Access Compliance Report

Public Rights-of-Way

Intersection ID: 24381	Main Street: MIROW_PL	Cross Street: STARGARD_CT	Location: S
ADA ID: 19A953AAF82C	Ramp Type: PerpDiag	Initial Pass/Fail: Fail	Overall Compliance: No
		Severity Score: 12.5

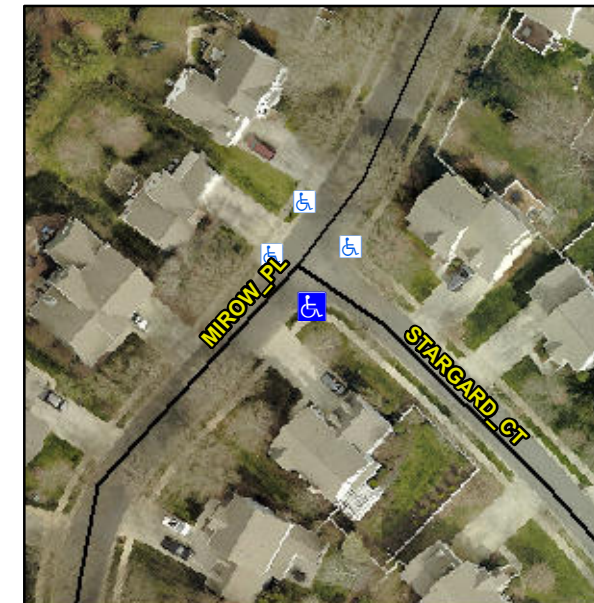
Not Found, R304.5.3

Compliance	Description	Data	Compliance	Description	Data
N/A	Ramp Length (in)	48.0	Yes	Ramp Slope (%)	7.0
Yes	Ramp Width (in)	48.0	No	Ramp XSlope (%)	6.5
N/A	Flare Type LT	N/A	N/A	Flare Type RT	N/A
N/A	Flare Slope LT (%)	N/A	N/A	Flare Slope RT (%)	N/A
N/A	Flare Traversable LT?	N/A	N/A	Flare Traversable RT?	N/A
N/A	Landing Length (in)	N/A	N/A	DWS Provided?	N/A
N/A	Landing Width (in)	N/A	N/A	DWS Contrast?	N/A
N/A	Landing Slope (%)	N/A	N/A	DWS Length (in)	N/A
N/A	Landing X Slope (%)	N/A	N/A	DWS Full Width?	N/A
N/A	Landing Curb? (Y/N)	N/A	N/A	DWS Offset (in)	N/A
N/A	Shared Landing?	N/A			
N/A	Gutter Ponding?	N/A	N/A	Gutter Slope (%)	N/A
N/A	Gutter Lip Ht (in)	N/A	N/A	Gutter X Slope (%)	N/A
N/A	Painted X Walk1?	No	N/A	Painted X Walk2?	No
	X Walk 1 Direction	To NE		X Walk 2 Direction	To NW
N/A	X Walk 1 Width (in)	N/A	N/A	X Walk 2 Width (in)	N/A
	X Walk 1 Slope (%)	5.3		X Walk 2 Slope (%)	2.2
	X Walk 1 X Slope (%)	3.5		X Walk 2 X Slope (%)	5.4

Remove & Replace Curb Ramp With Two New Directional Ramps or Equivalent.
